Access Compliance Report

Public Rights-of-Way

(Curb Ramps)

Intersection ID: 14095	Main Street: CAMDEN_RD	Cross Street: W_WORTHINGTON_AV	Location: SW
ADA ID: 2CF728BF9D89	Ramp Type: BlendTrans2	Initial Pass/Fail: Fail	Overall Compliance: No
		Severity Score: 8.75

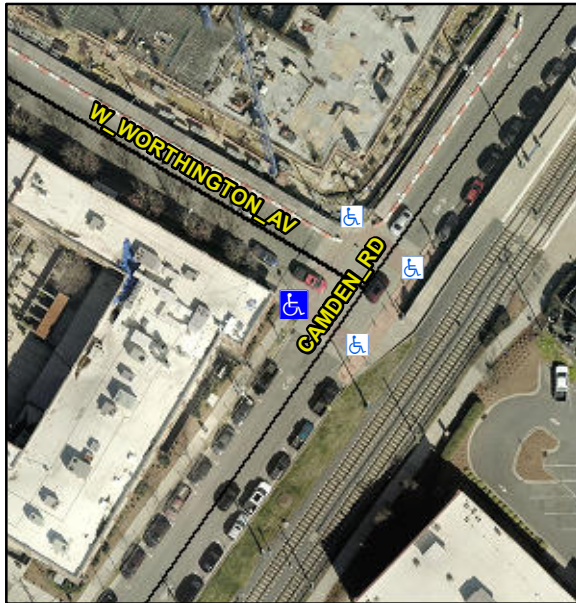
Not Found, R304.5.1

Compliance	Description	Data	Compliance	Description	Data
N/A	Ramp Length (in)	41.0	Yes	BlendTrans Slope (%)	2.8
No	Ramp Width (in)	43.0	Yes	BlendTrans XSlope (%)	1.0
N/A	Flare Type LT	N/A	N/A	Flare Type RT	N/A
N/A	Flare Slope LT (%)	N/A	N/A	Flare Slope RT (%)	N/A
N/A	Flare Traversable LT?	N/A	N/A	Flare Traversable RT?	N/A
N/A	Landing Length (in)	N/A	N/A	DWS Provided?	N/A
N/A	Landing Width (in)	N/A	N/A	DWS Contrast?	N/A
N/A	Landing Slope (%)	N/A	N/A	DWS Length (in)	N/A
N/A	Landing X Slope (%)	N/A	N/A	DWS Full Width?	N/A
N/A	Landing Curb? (Y/N)	N/A	N/A	DWS Offset (in)	N/A
N/A	Shared Landing?	N/A			
N/A	Gutter Ponding?	N/A	N/A	Gutter Slope (%)	N/A
N/A	Gutter Lip Ht (in)	N/A	N/A	Gutter X Slope (%)	N/A
N/A	Painted X Walk1?	Yes	N/A	Painted X Walk2?	Yes
	X Walk 1 Direction	To SE		X Walk 2 Direction	To NE
	X Walk 1 Width (in)	121.0		X Walk 2 Width (in)	119.0
	X Walk 1 Slope (%)	0.6		X Walk 2 Slope (%)	1.0
	X Walk 1 X Slope (%)	2.4		X Walk 2 X Slope (%)	0.9

N/A	Ramp inside XWalk1?	Yes	N/A	Ramp inside XWalk2?	Yes
	Road Slope (%)	0.0		Clear Space?	N/A
	Road X Slope (%)	2.0	N/A	Clear Space to XWalk (in)	N/A
N/A	Any Obstructions?	N/A	N/A	Storm Grate/Utility Hazard?	N/A
	Obstruction Type			Storm Grate/Utility Type	
		N/A			N/A
			Yes	Surface Condition? (G/P)	Good
			No	Curb Slope (%)	11.1

Remove & Replace Curb Ramp With Two New Directional Ramps or Equivalent.
